# ADDENDUM #1

**PROJECT #:** 242762  
**PROJECT TITLE:** AJ Jolly Dam Repair  
**CLIENT:** Campbell County Fiscal Court  
**Issue Date:** April 21, 2026

**SPILLWAY DEMOLITION PLAN**  
 SCALE: 3/32" = 1'-0"

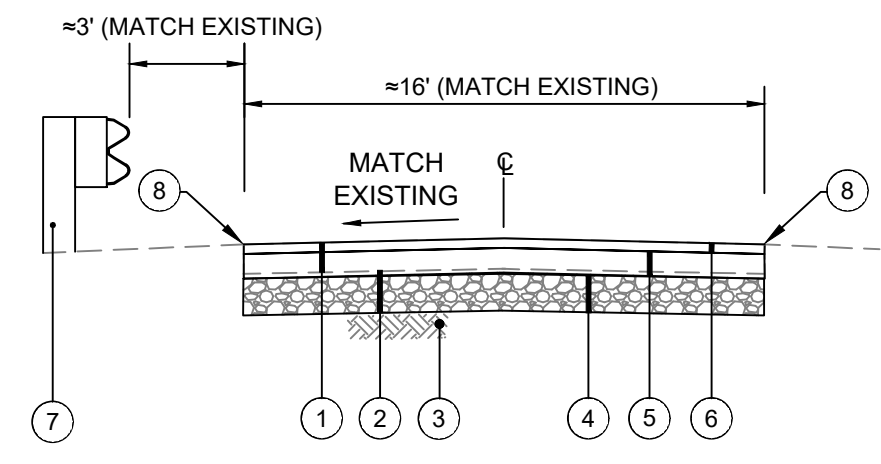
SHEET D-100  
*Renamed Roadway Demolition Hatch to Bridge Approach Demolition. This matches Bid Form Items 18, 19, and 20.*

**SUBGRADE REPAIR DETAIL\*** N.T.S.

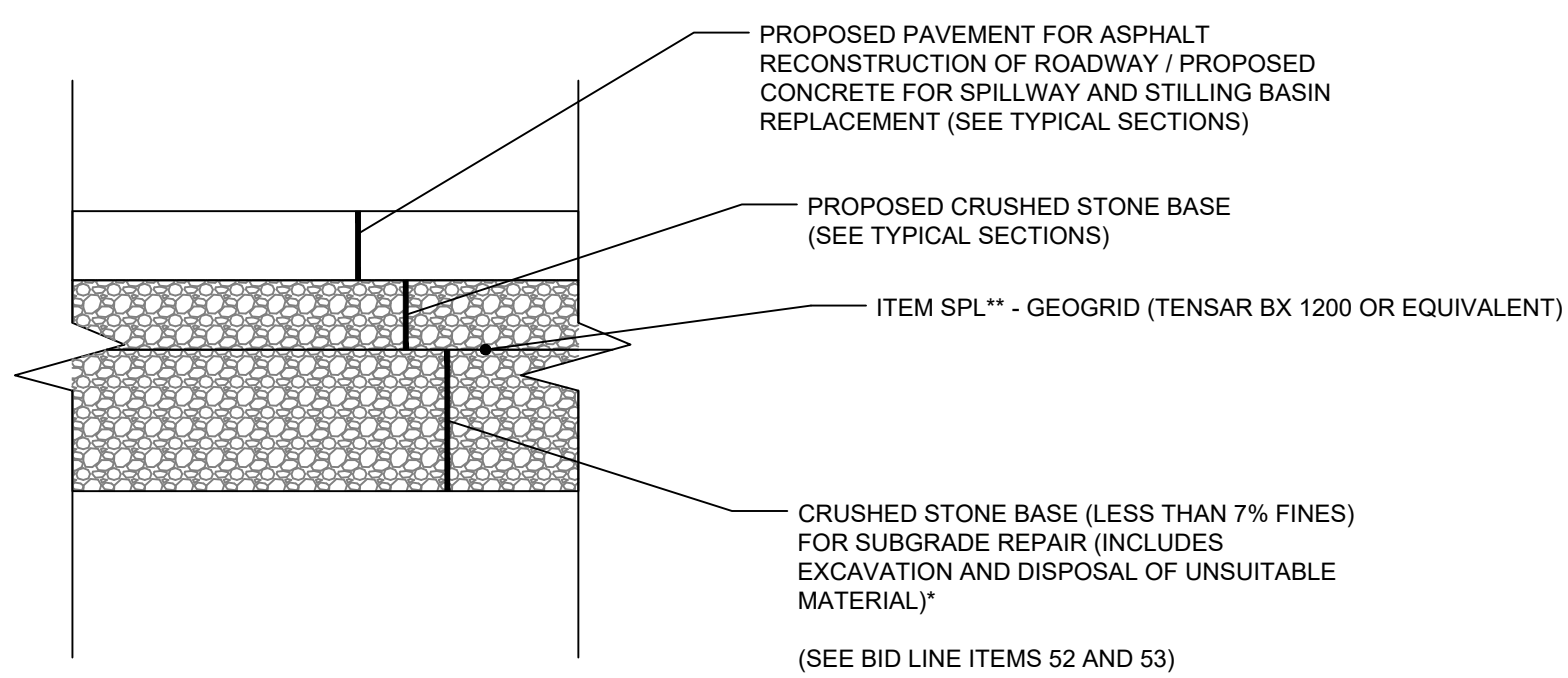
6. Will undercut of the existing slab be necessary?

SHEET C-101

*A contingency bid item, Bid Item 52 was added which provides for 1' of undercut and backfill for 20% of the Concrete for the Spillway and Stilling Basin Replacement.*

*A contingency bid item, Bid Item 53 was added which provides for 1' of undercut and backfill for 10% of the Asphalt Reconstruction of Roadway*

*A detail for corresponding with these items has been added on page C101*

*Added Subgrade Repair Detail corresponding to new Bid Form Items 52, 53, and 54.*

DATE: MARCH 31, 2026  
 SCALE: AS NOTED  
 SHEET: C-400

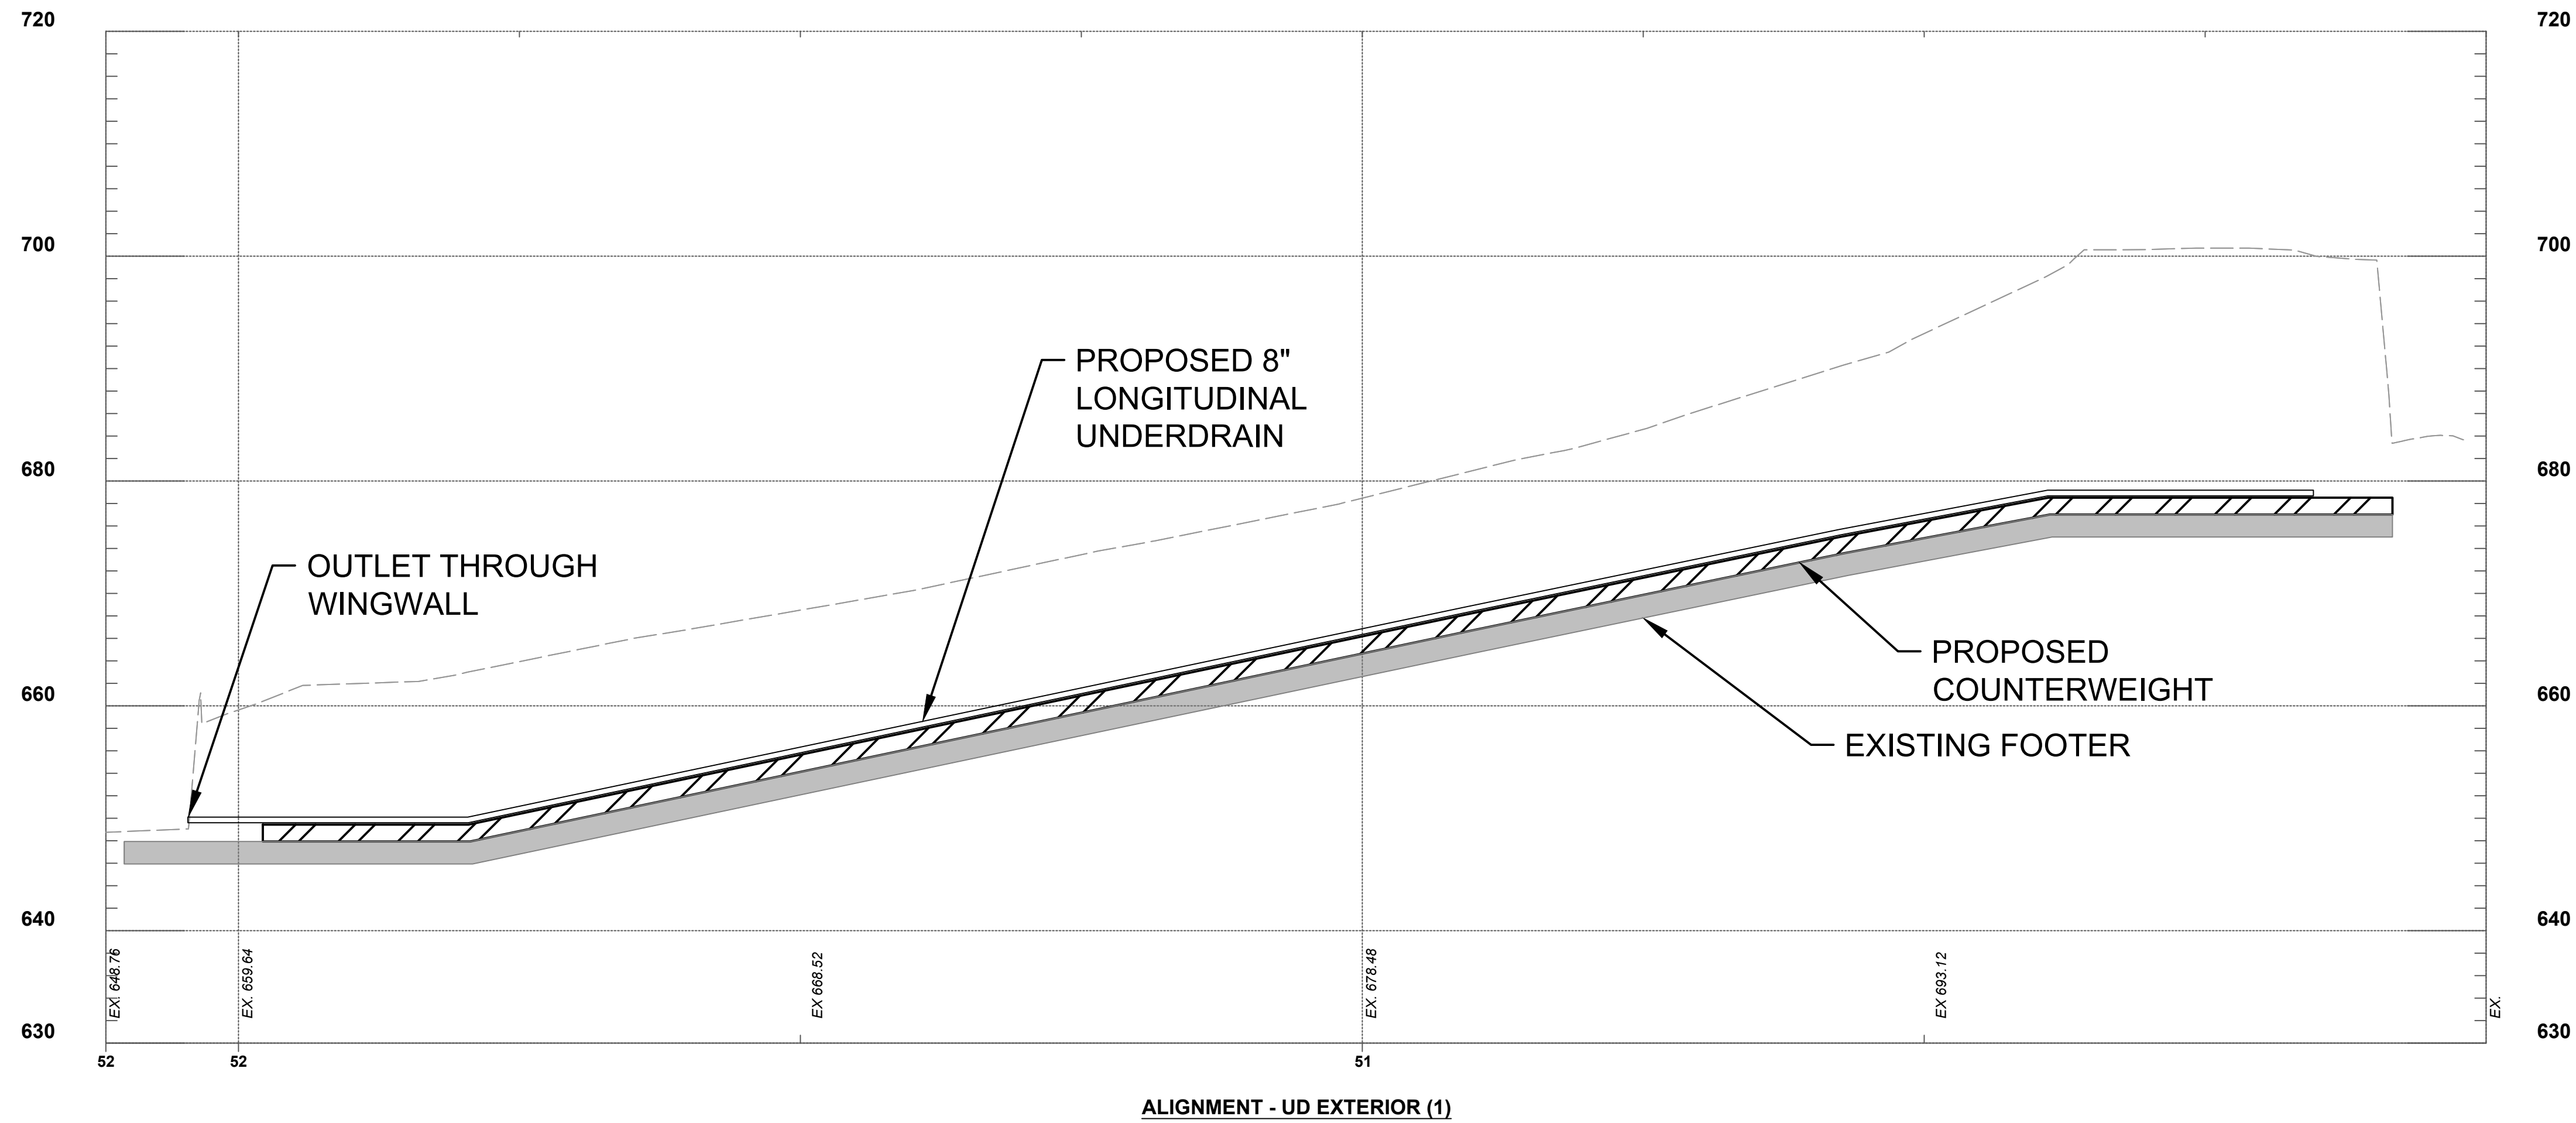
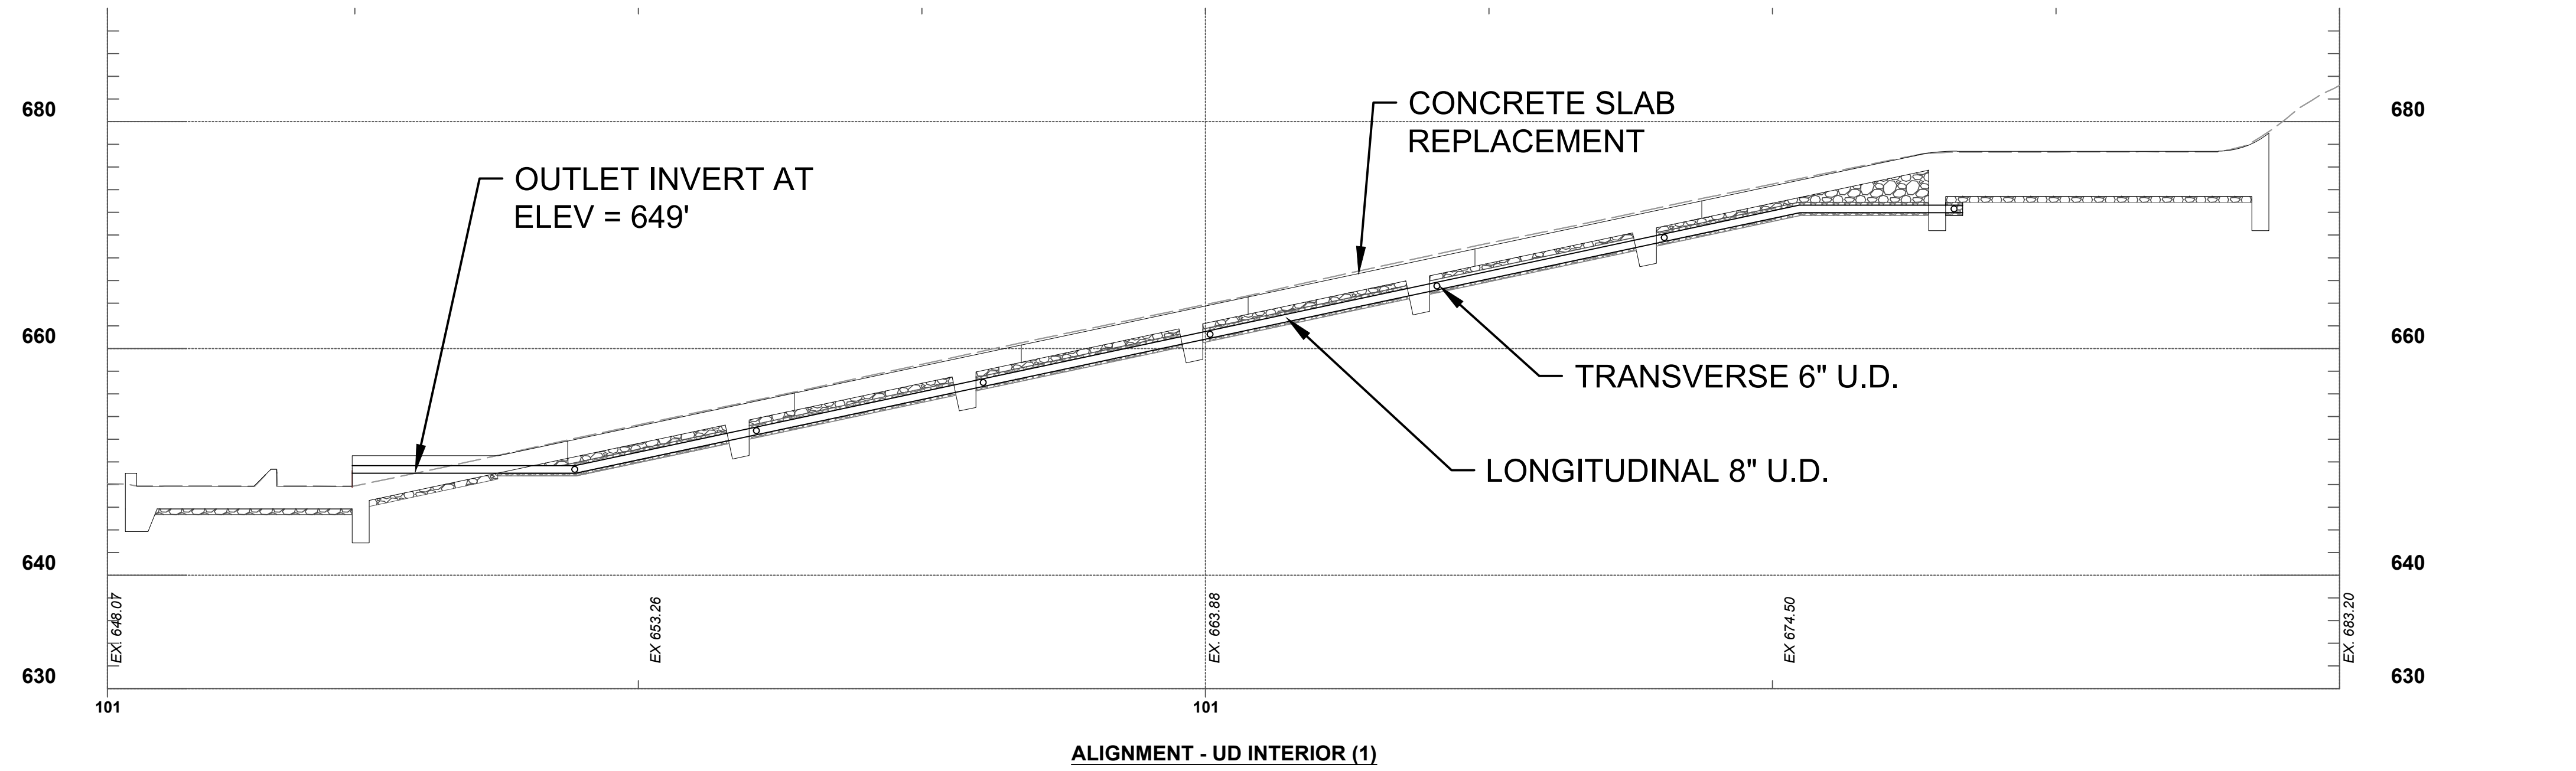
Bid Form Item 10: Subgrade reshaping and compaction. Please show the limits of this work on a drawing.

SHEET C-400

*Response: The limits of this work is shown on page G104 with the Asphalt Reconstruction of Roadway Section Hatch, on page C400 with the Asphalt Reconstruction of Bridge Approaches Hatch and on page C400 with the 18" Concrete Spillway Slab Replacement Hatch. This quantity has also been revised.*

*Keynote 10 Leader at Interior Longitudinal U.D. corrected to Keynote 7 Leader.*

*Hatch Legend language updated to match Details and Bid Form language.*

*Interior Longitudinal U.D. extended to outlet at end of Chute Block.*
